TECHNICAL BULLETIN
Bell Helicopter

No. 407-08-85

SUBJECT: FUEL TRANSFER LIGHT DELAY RELAYS,
INSTALLATION OF

HELICOPTERS AFFECTED: 407 Helicopters serial number 53000 through
53799

Figure 1: Forward transfer pump assembly

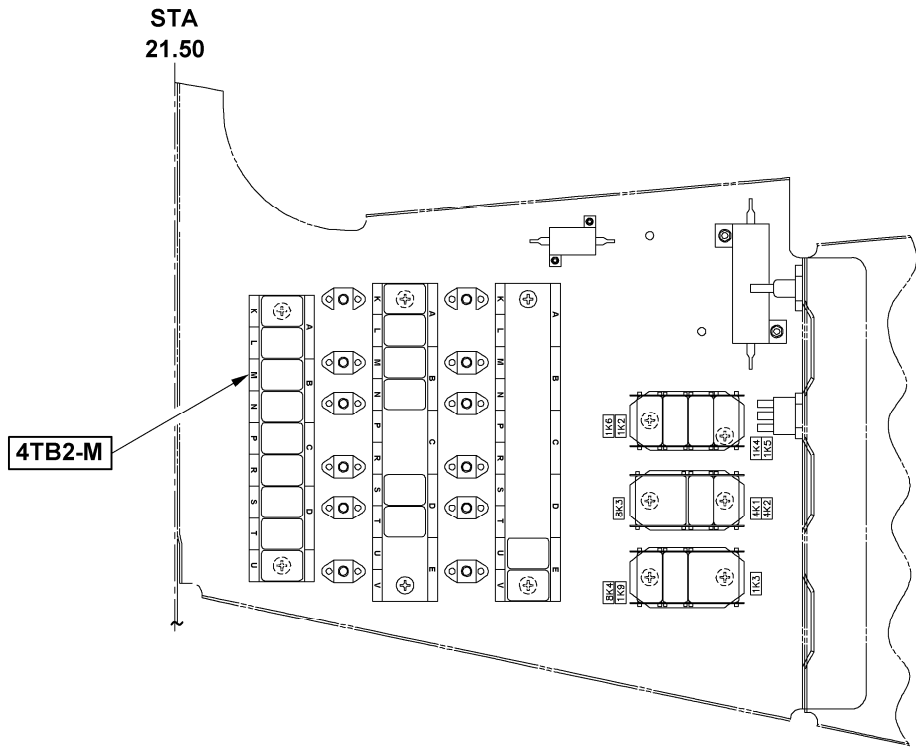
1. Prepare the helicopter for maintenance.
2. Ensure all electrical power is removed from the helicopter.
3. Disconnect the helicopter battery.
4. Remove fuel transfer pump assembly (Refer to BHT-407-MM-4 Chapter 28).
5. Remove cap assembly P/N AN929-6 (Refer to Figure 1).
6. Install restrictor P/N 407-062-033-101.
7. Reinstall fuel transfer pump assembly (Refer to BHT-407-MM-4 Chapter 28).
8. Continue on to **Part II**.

- 1 Remove existing cap and install restrictor.

1. Restrictor 407-062-033-101

Figure 2: Wiring Installation Sheet 1 of 2

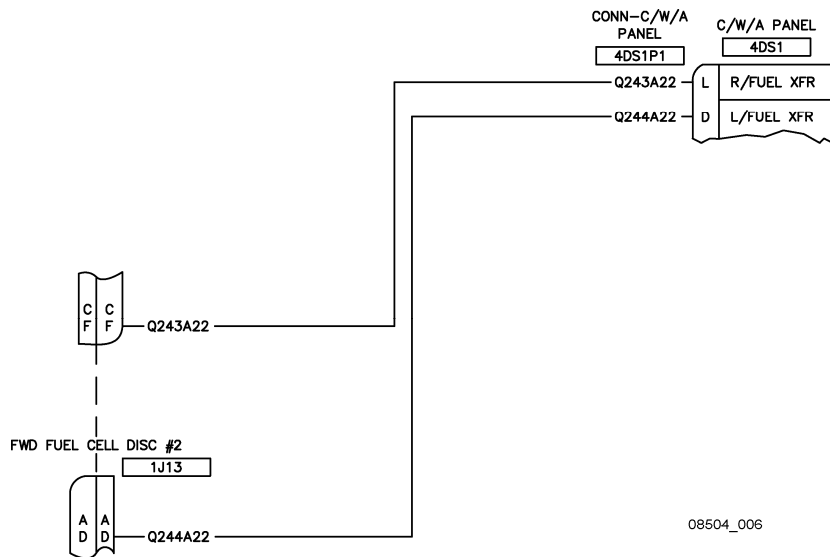
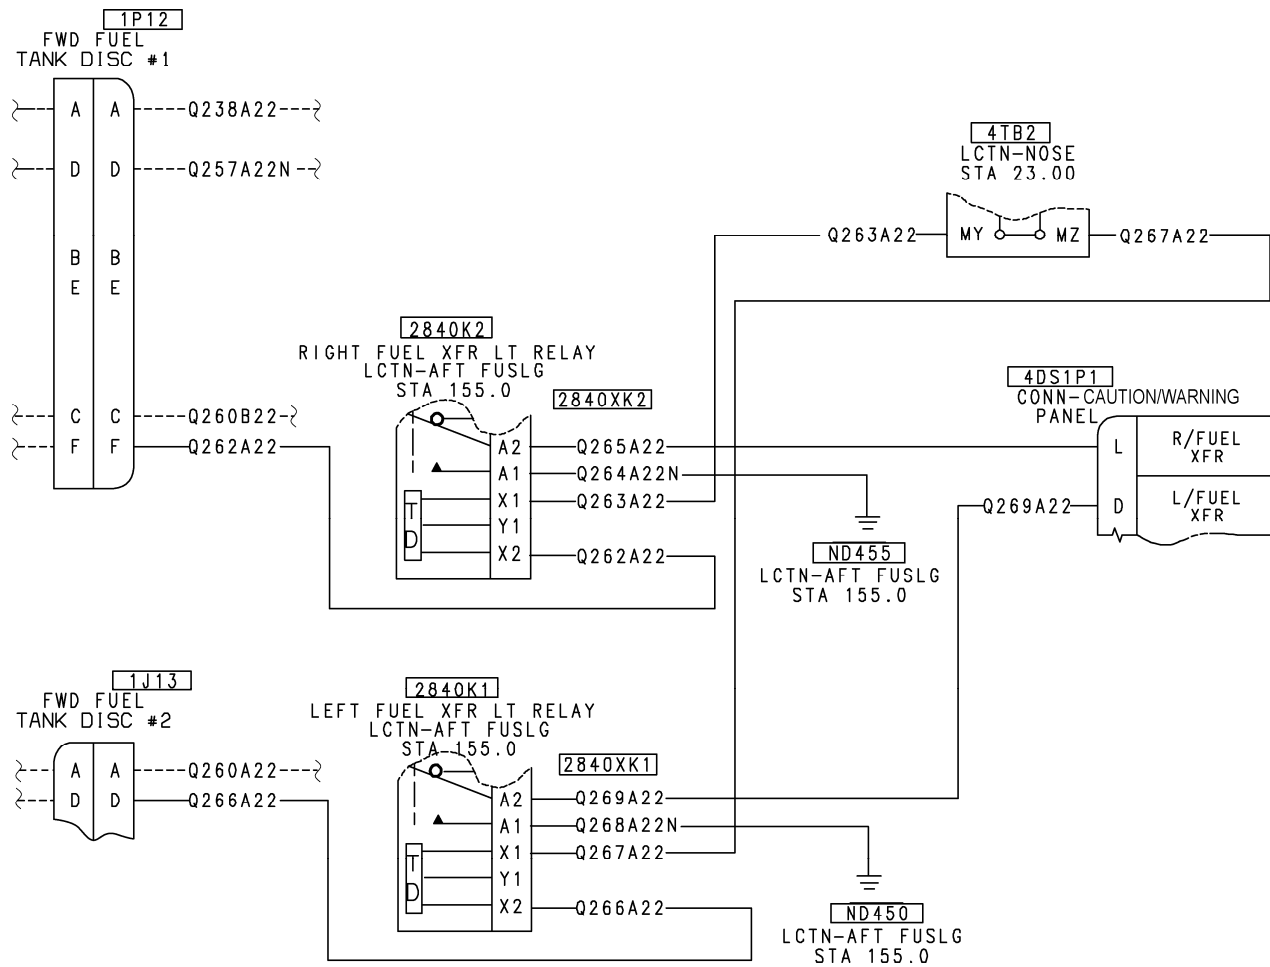
1. Prepare the helicopter for maintenance.
2. Ensure all electrical power is removed from the helicopter.
3. Disconnect the helicopter battery.
4. Remove forward and aft interior headliner as well as hat bin and windshield centre pillar panel (Refer to BHT-407-MM-3 Chapter 25).
5. Remove Pilot seat panel assembly and centre covers between Pilot and Copilot seats as well as R/H and L/H nose console side panels (Refer to 407-MM-5 Chapter 53).
6. Gain access to the terminal board 4TB2 module M located at left side FWD relay panel (Refer to Figure 2).
7. Refer to the wiring modifications instruction table at bottom of Figure 2 sheet 2 to determine actions required.

Wires from 2840XK1 and 2840XK2 to 4TB2, 4DS1P1, 1P12 and 1J13 will pass in main wiring harness that is located next to Box Beam R/H side. Refer to BHT-ELEC-SPM for wire termination procedures

Figure 2: Wiring Installation Sheet 2 of 2

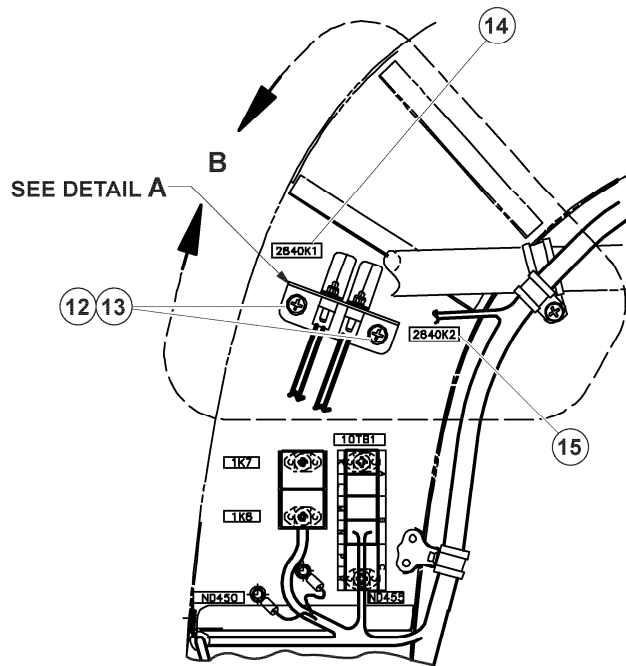
8. Perform the "DELETE" actions listed in the Wiring Modifications Table.

9. Perform the "ADD" actions listed in the Wiring Modifications Table.

WIRING MODIFICATIONS INSTRUCTION TABLE						
ACTION	WIRE #	LENGTH (FEET)	FROM	HARDWARE	TO	HARWARE
DELETE	Q243A22	-	1P12-F	-	4DS1P1-L	-
DELETE	Q244A22	-	1J13-D	-	4DS1P1-D	-
ADD	Q262A22	30	1P12-F	M39029/22-192	2840XK2-X2	M39029/92-533
ADD	Q263A22	22	2840XK2-X1	M39029/92-533	4TB2-MY	M39029/22-191
ADD	Q264A22N	2	2840XK2-A1	M39029/92-533	ND455	MS25036-103
ADD	Q265A22	22	2840XK2-A2	M39029/92-533	4DS1P1-L	M39029/35-27
ADD	Q266A22	30	1J13-D	M39029/22-192	2840XK1-X2	M39029/92-533
ADD	Q267A22	22	2840XK1-X1	M39029/92-533	4TB2-MZ	M39029/22-191
ADD	Q268A22N	2	2840XK1-A1	M39029/92-533	ND450	MS25036-103
ADD	Q269A22	22	2840XK1-A2	M39029/92-533	4DS1P1-D	M39029/35-27

Figure 3. Station 155.0 Bracket and Relay Installation

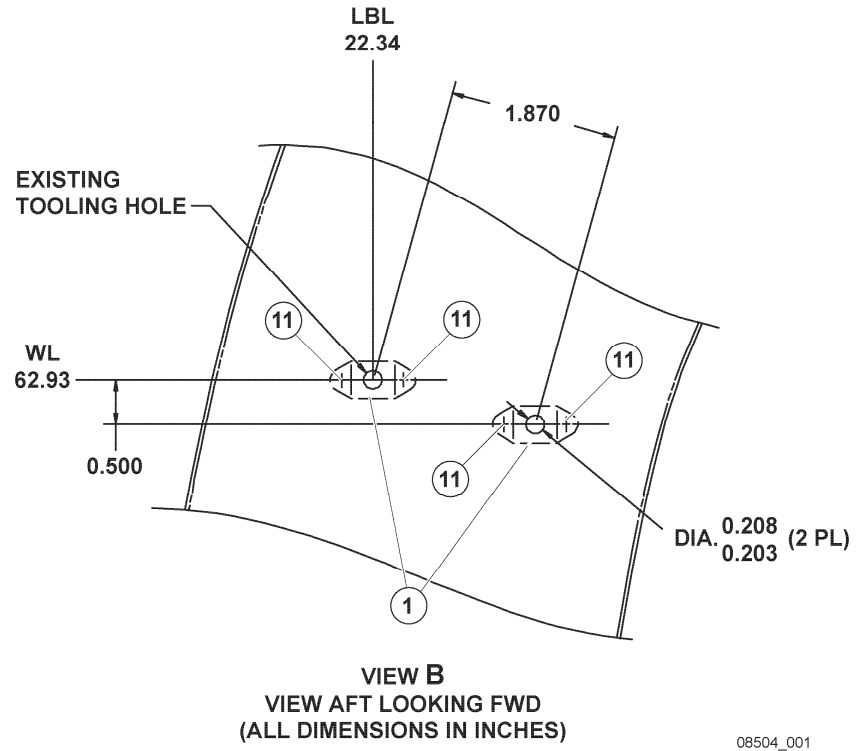
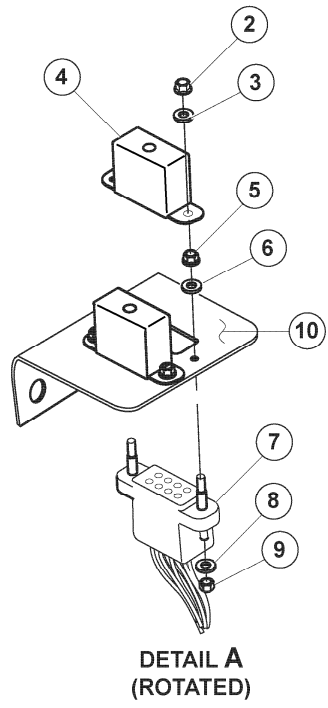
Relays and relay socket must be assembled on bracket prior to installation on airframe, therefore leave enough length on applicable wires before installation.

10. Install Bracket and relays (Refer to Figure 3 and BHT-206-SRM-1).

- i. Use existing tooling hole as reference for second hole.
- ii. Drill and deburr both holes 0.203 - 0.208 inch (5.1562 – 5.2832 mm).
- iii. Locate, drill and deburr nutplate securing holes.
- iv. Install nutplates (1) using rivets (11).
- v. Install relay sockets (7) and relays (4) on bracket (10) using nuts (2), (5), (9) and washers (3), (6), (8).
- vi. Install bracket (10) using screws (12) and washers (13).
